AMENDMENT 1

TIBET ROAD
(TRIBUTARY T TO E. 48TH AVE.)
SITE PLAN FOR INFRASTRUCTURE
TITLE: LANDSCAPE PLAN
DATE: February 24, 2023

TIBET ROAD (TRIBUTARY T TO E. 48TH AVE.)
SITE PLAN FOR INFRASTRUCTURE
TITLE: LANDSCAPE DETAILS
DATE: February 24, 2023

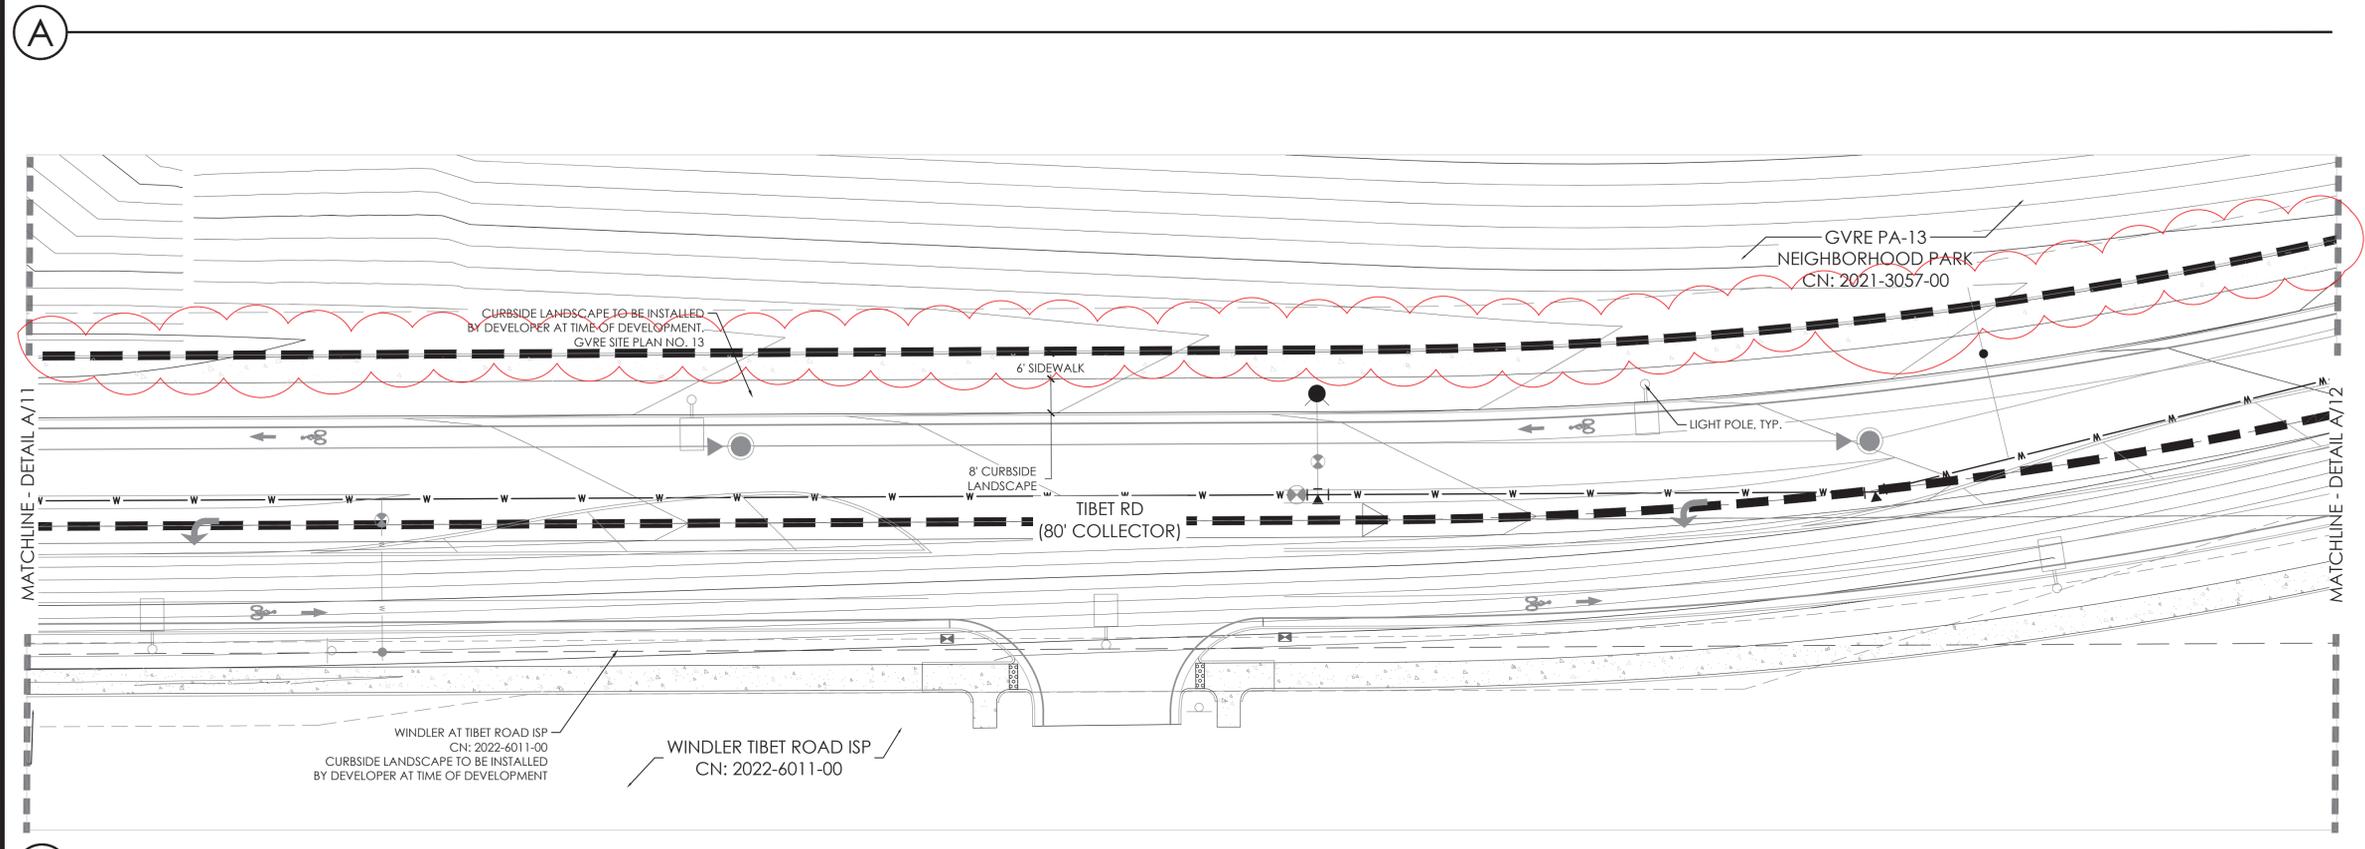
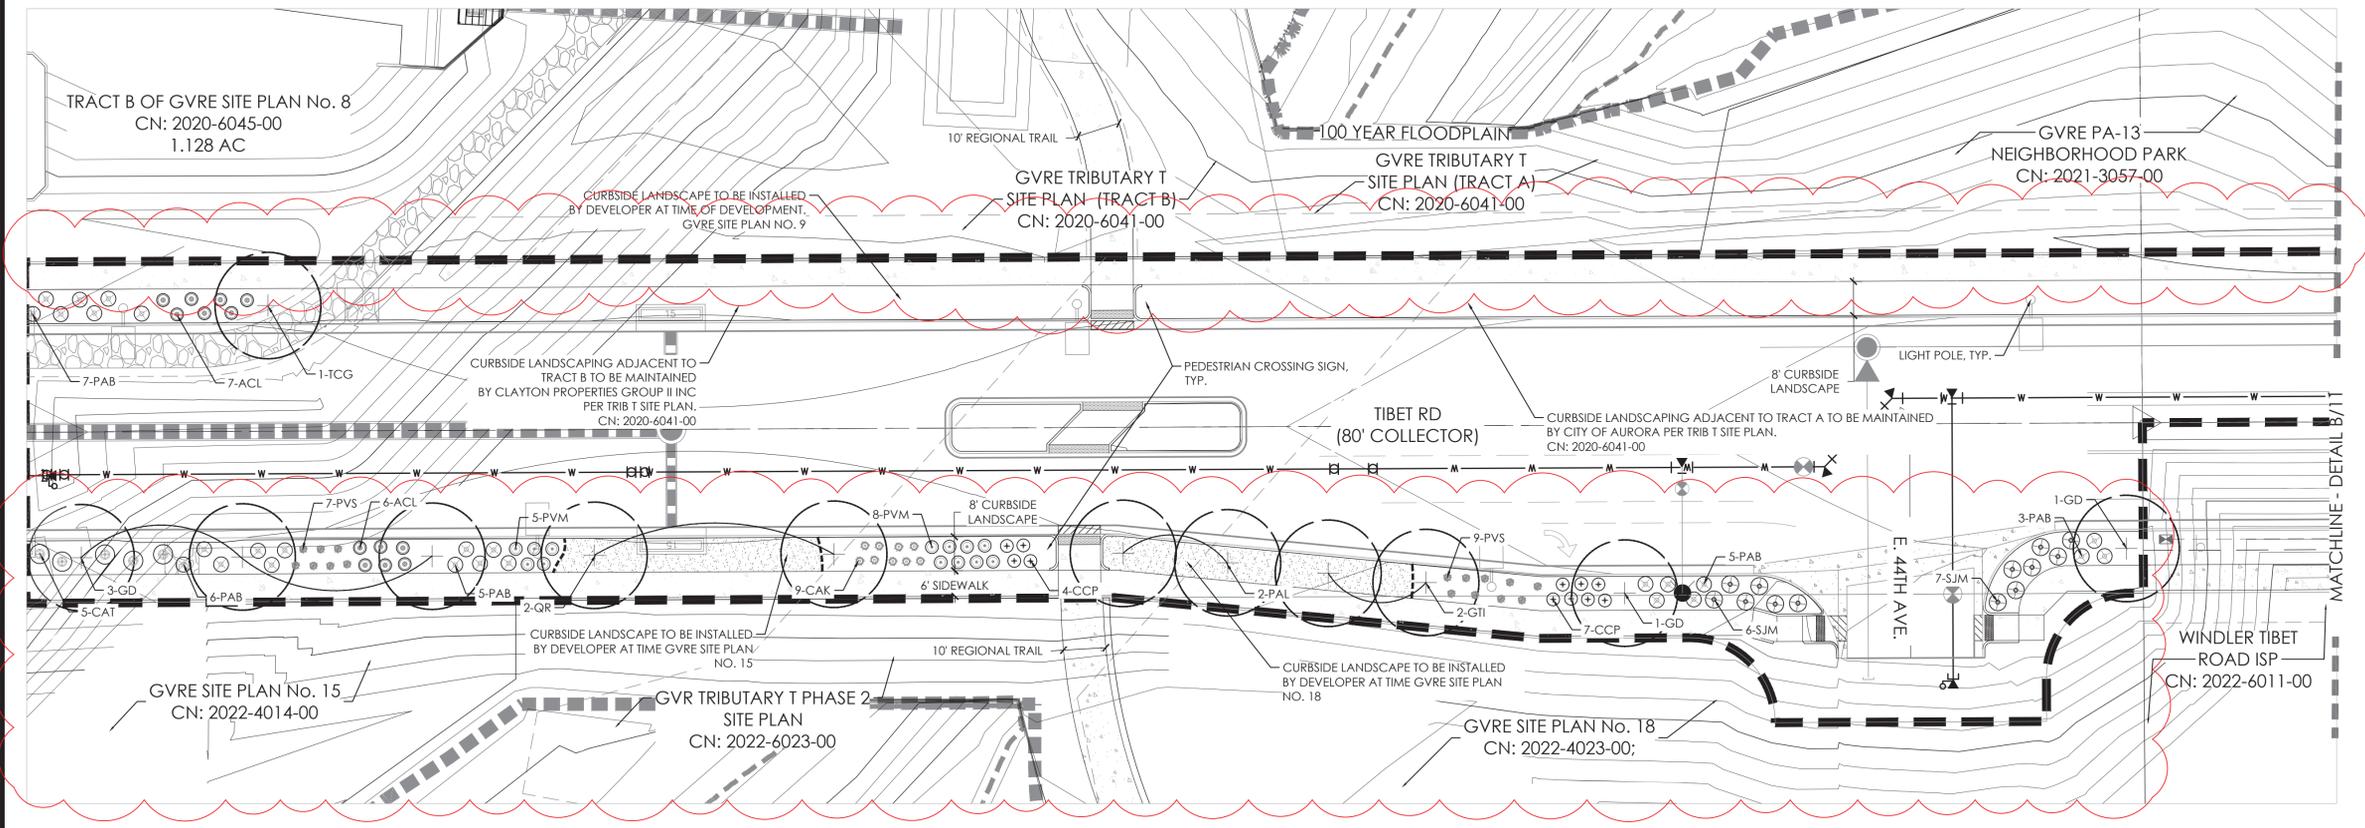
- REMOVE CRUSHER FINES BIKE PATH
- ADDED TURN LAND AND ROAD INTERSECTION INTO GVR FILING 18
- PLANTING ADDED TO CURBSIDE

TIBET ROAD
(TRIBUTARY T TO E. 48TH AVE.)
SITE PLAN FOR INFRASTRUCTURE
TITLE: LANDSCAPE PLAN
DATE: February 24, 2023

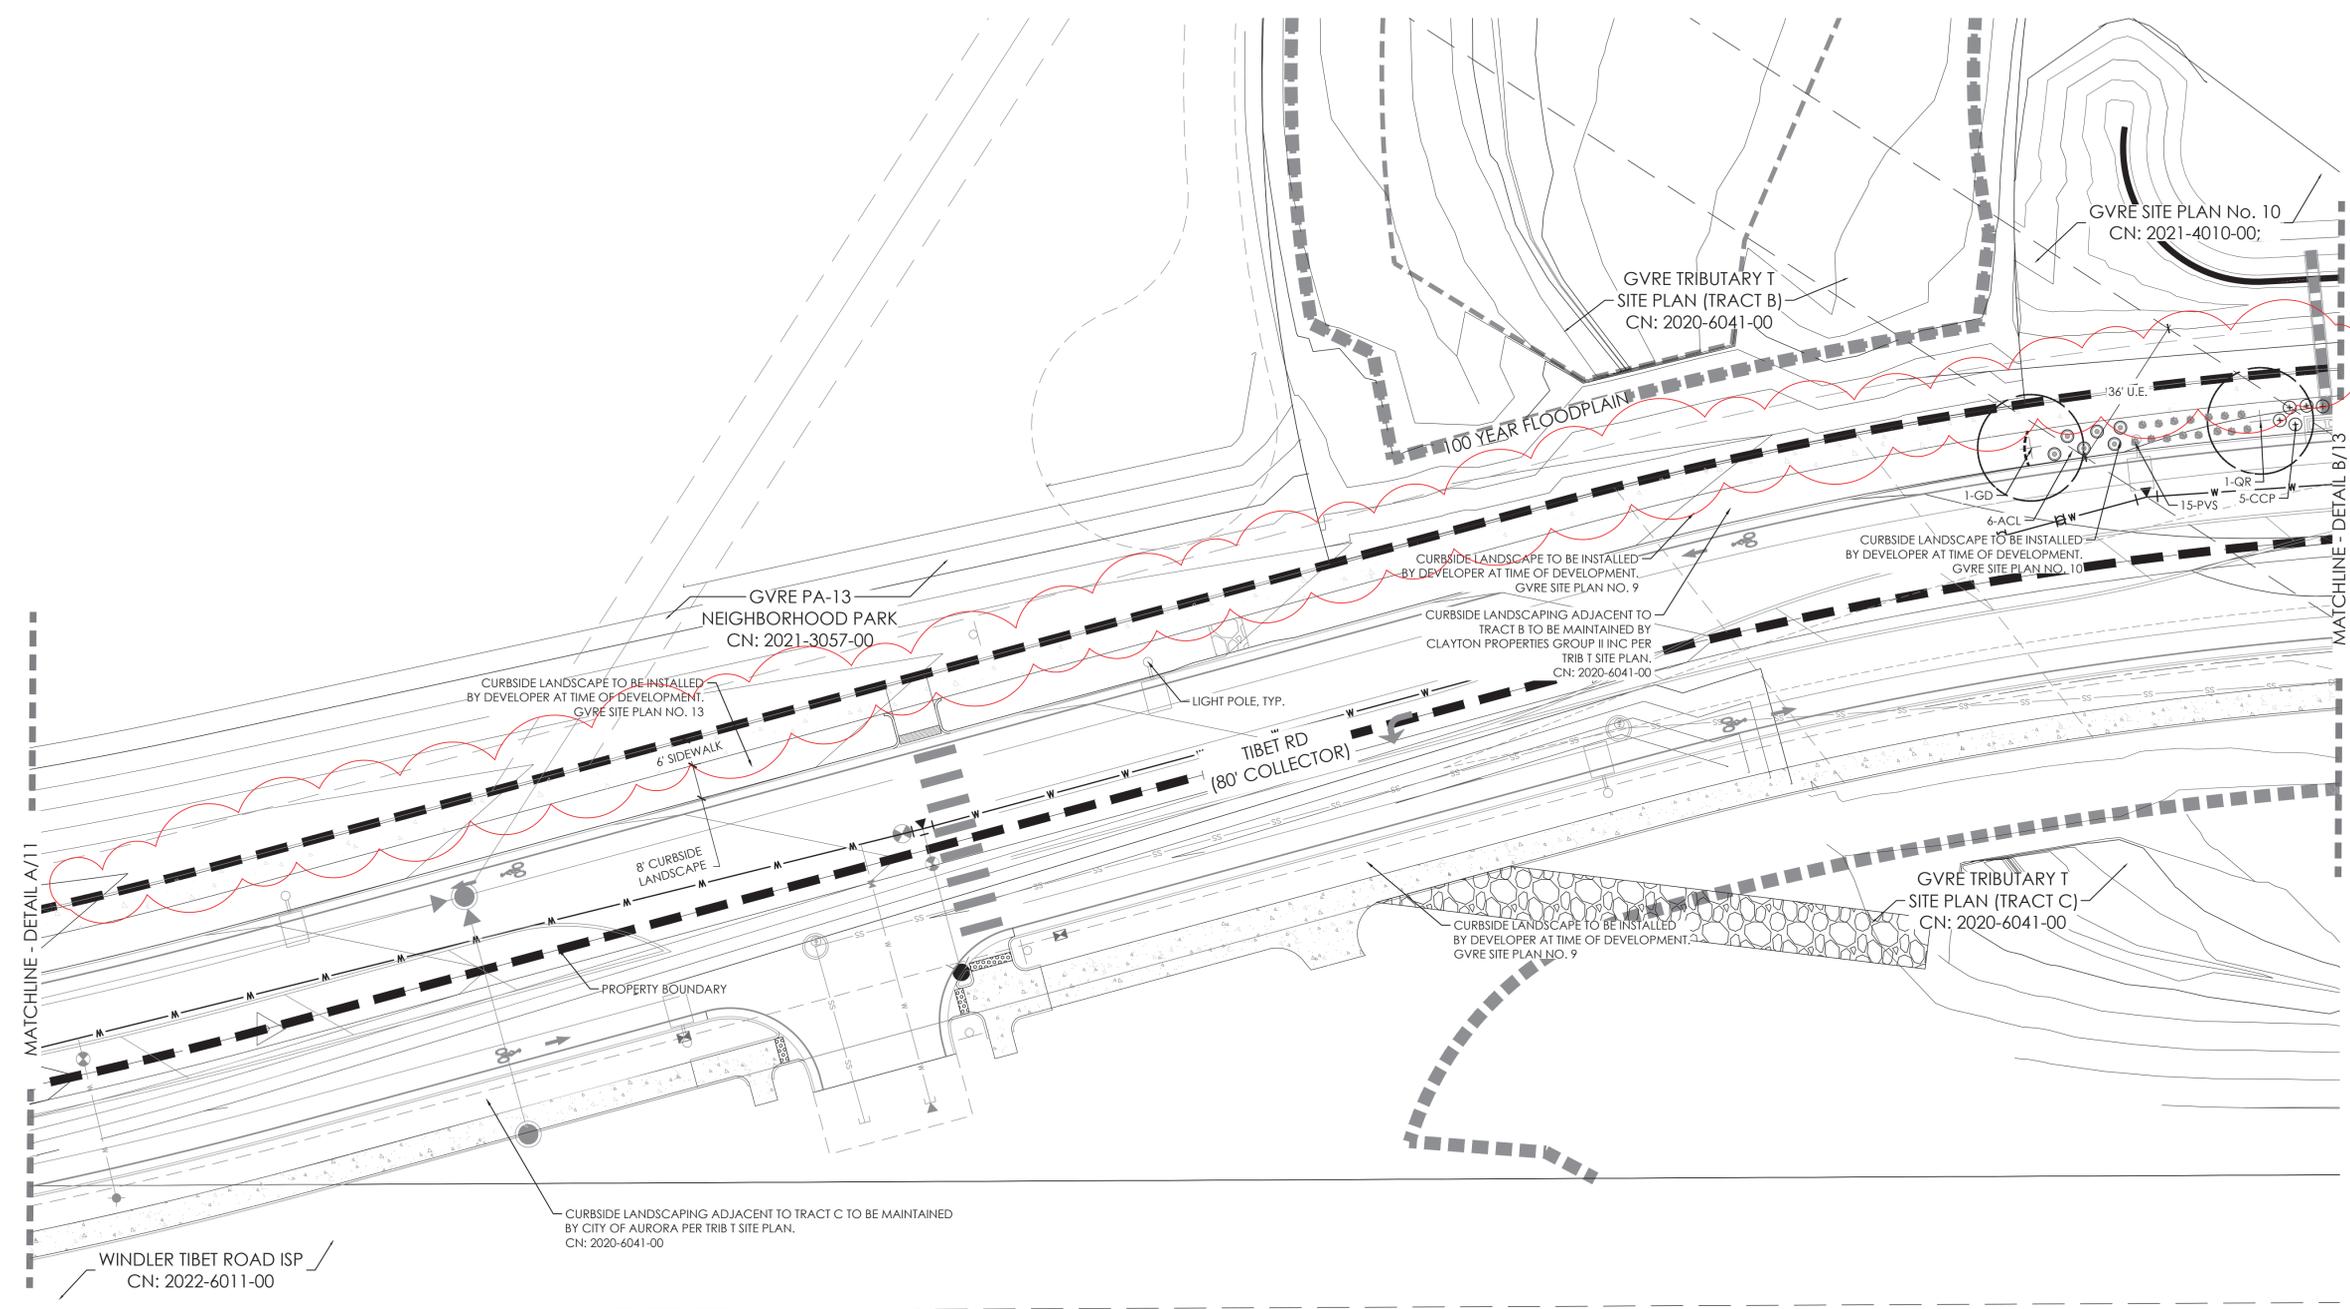
AMENDMENT 1
- REMOVE CRUSHER FINES BIKE PATH

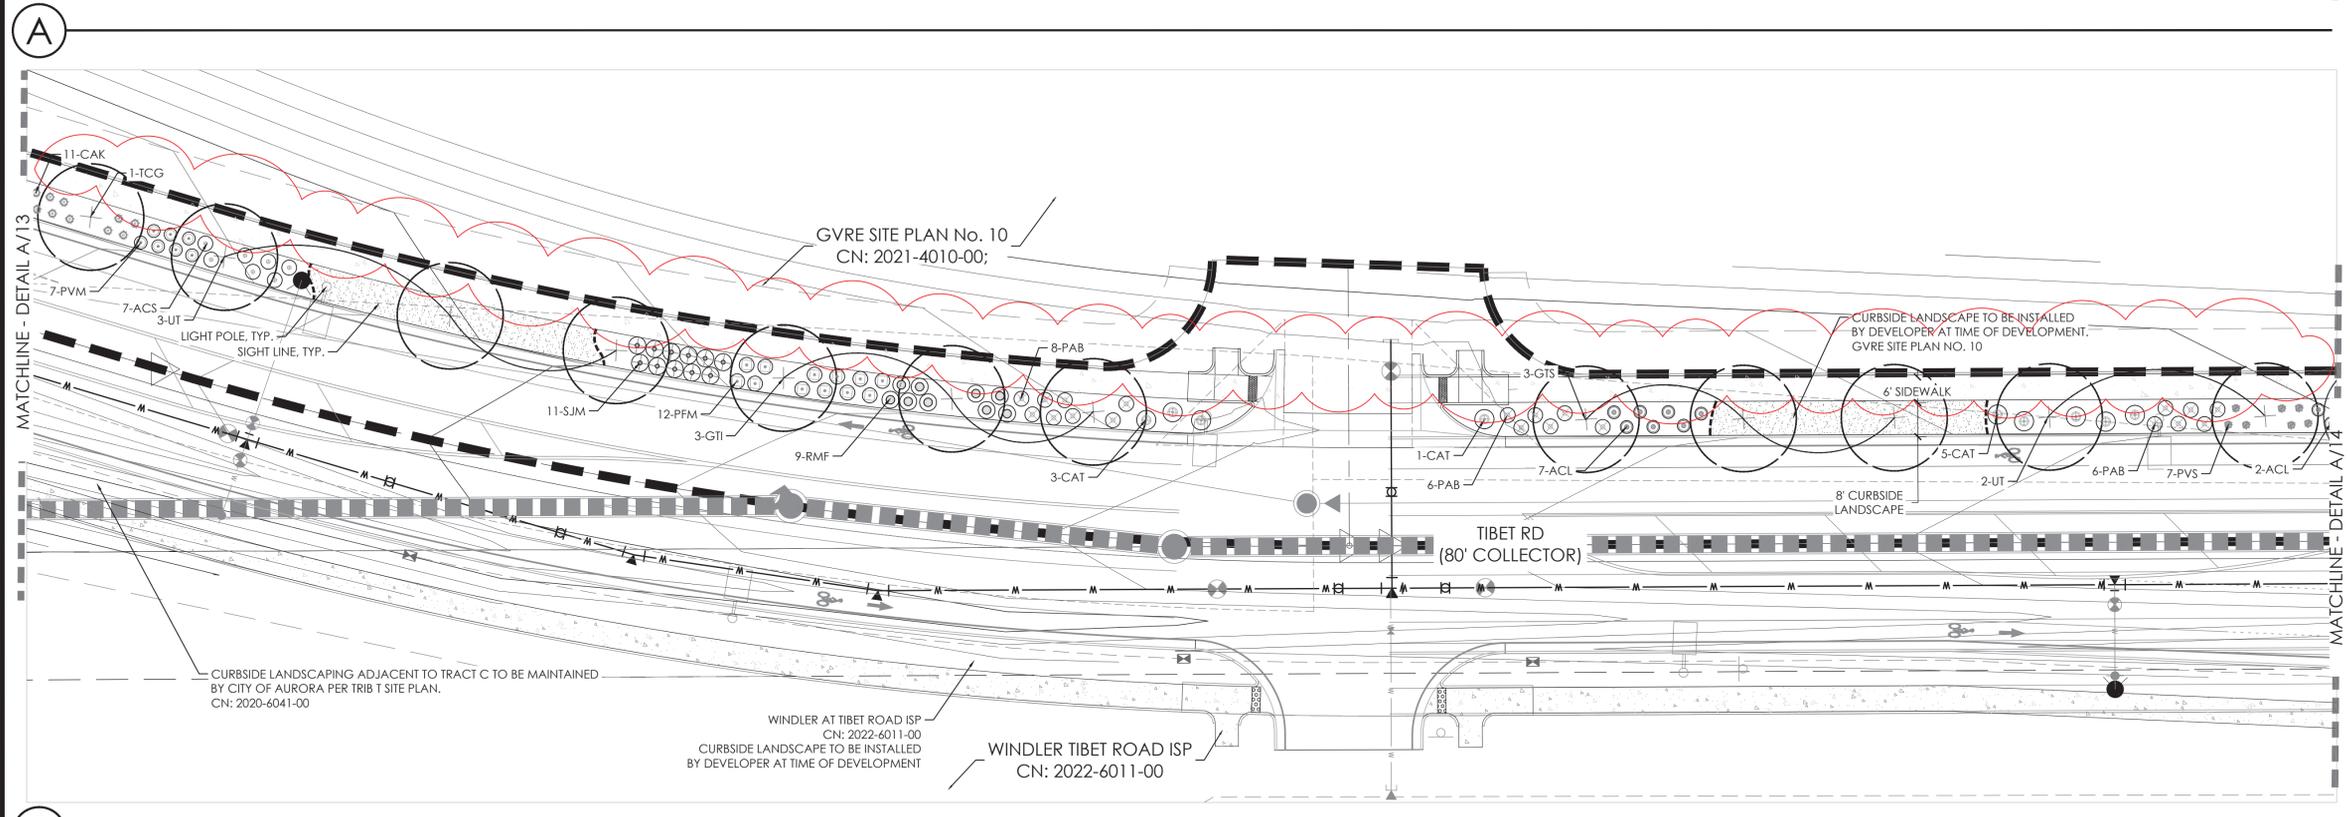
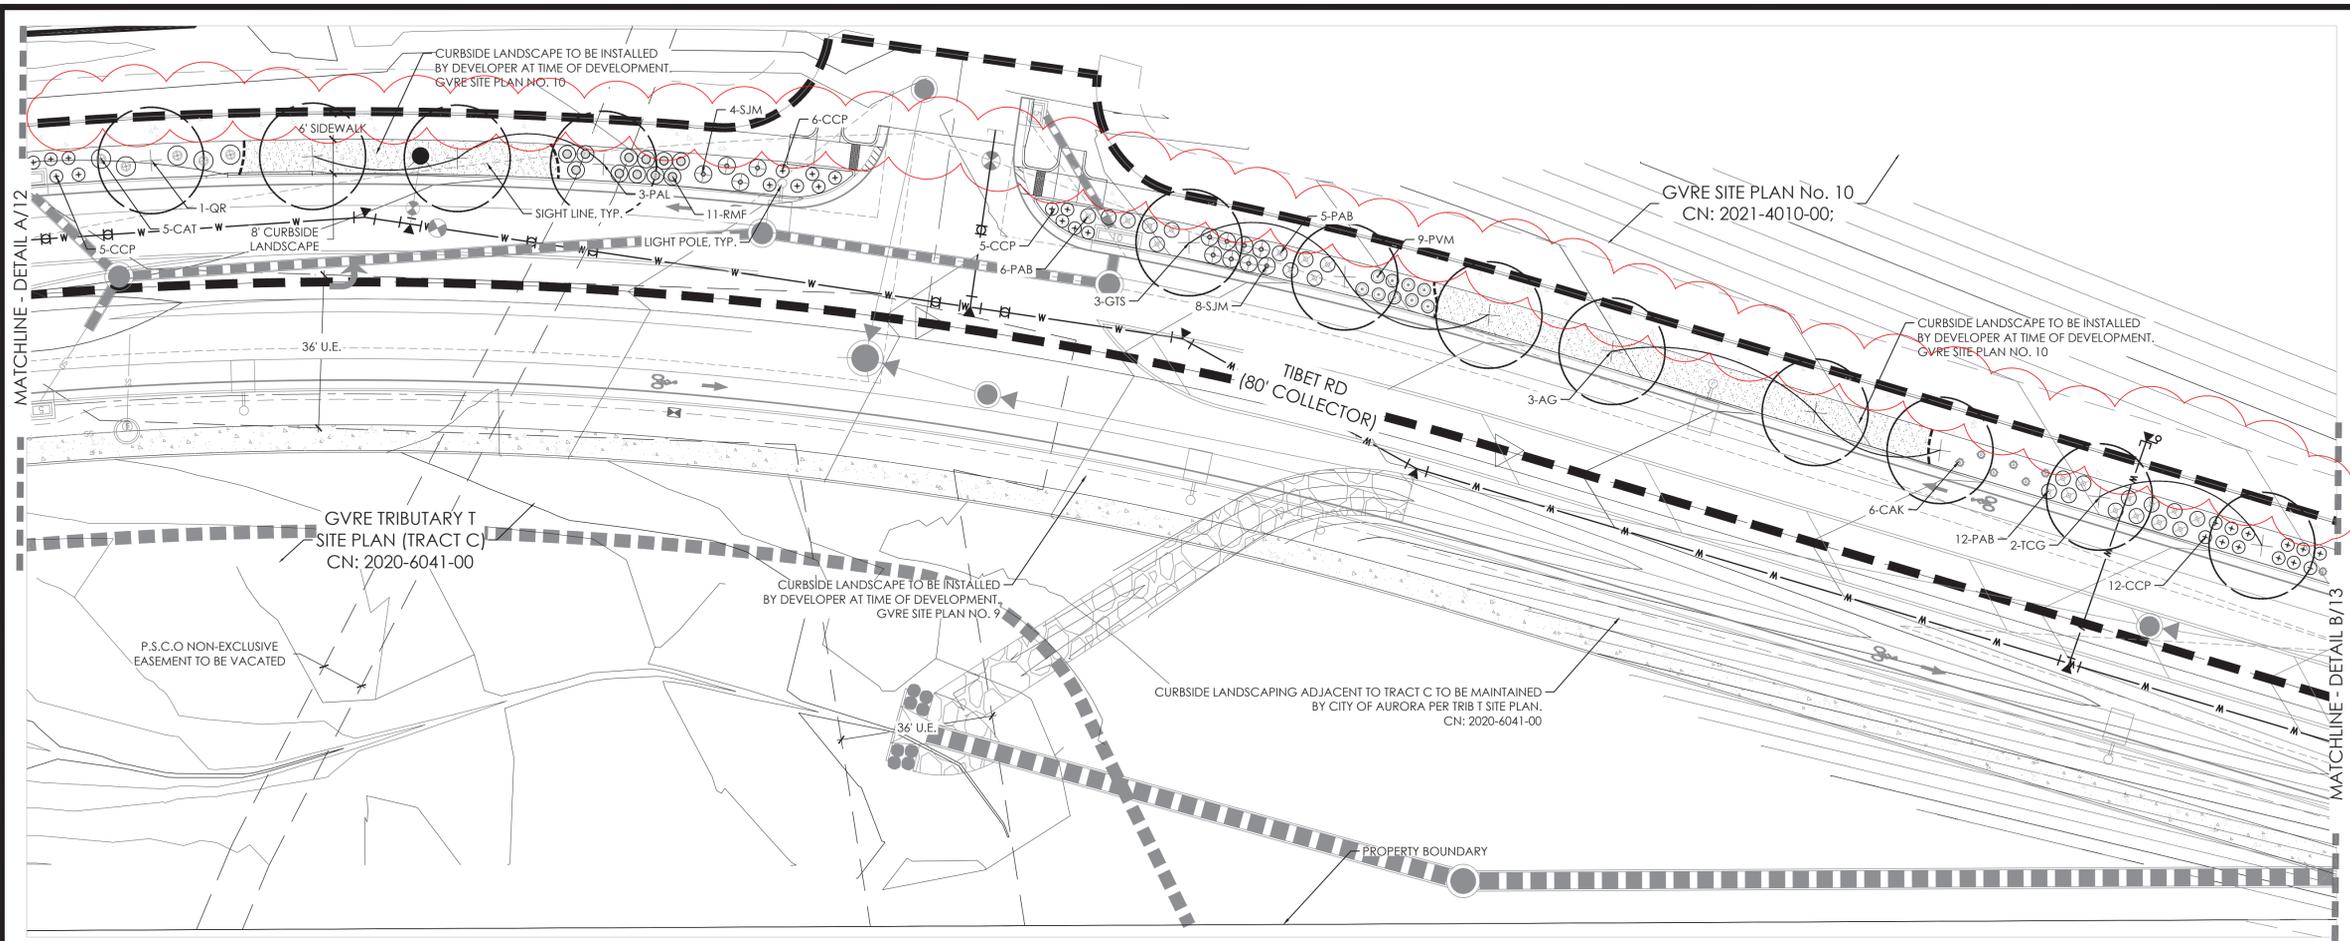
AMENDMENT 1
- REMOVE CRUSHER FINES BIKE PATH
